## Product Change Notification / SYST-25GSAN503

ERRATA - PIC16(L)F15356/75/76/85/86 Family Silicon Errata and Data Sheet Clarification Errata Document Revision

## PIC16(L)F15356/75/76/85/86 Family Silicon Errata and Data Sheet Clarification

### 3.1 Figure 37-5: Clock Timing

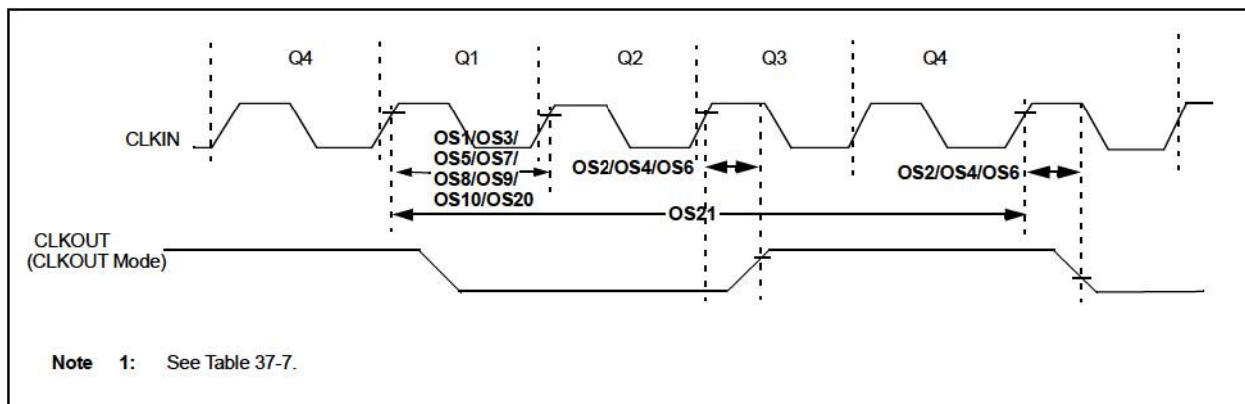
Figure 37-5 incorrectly shows the location of parameters OS1, OS2, OS3, OS4, OS5, OS6, OS7, OS8, OS9, OS10, OS20 and OS21. The correct location for the above-mentioned parameters is depicted in the following figure.

## 3.2 Figure 37-9: Brown-Out Reset Timing and Characteristics

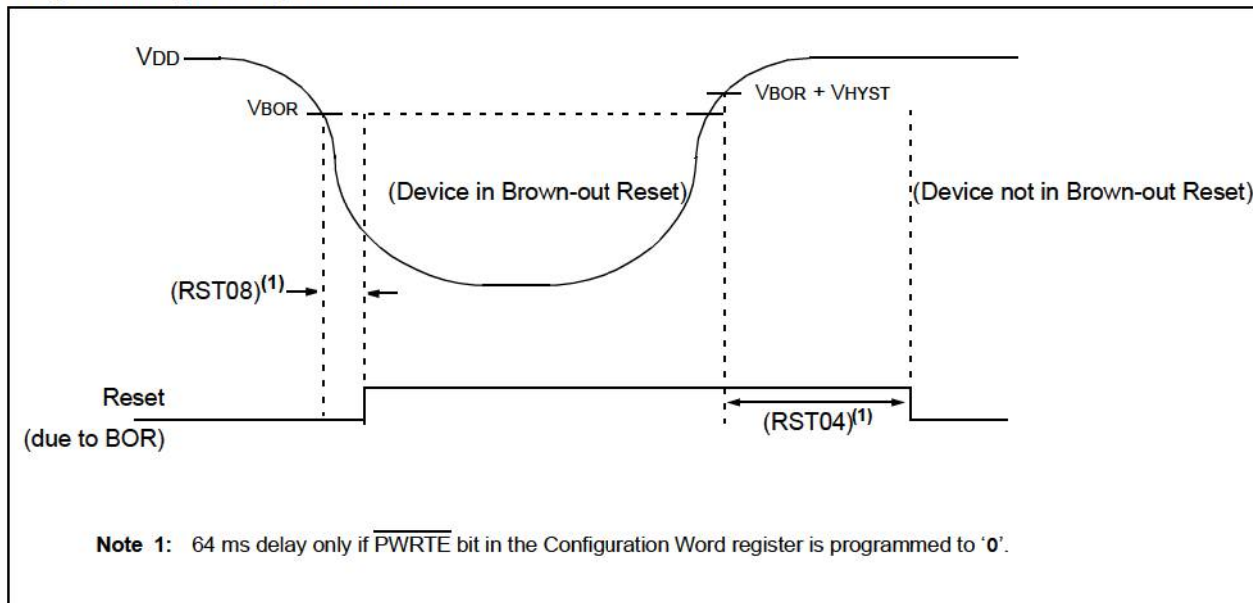
Note 1 in Figure 37-9 is incorrect. The correct note along with the figure is depicted below.
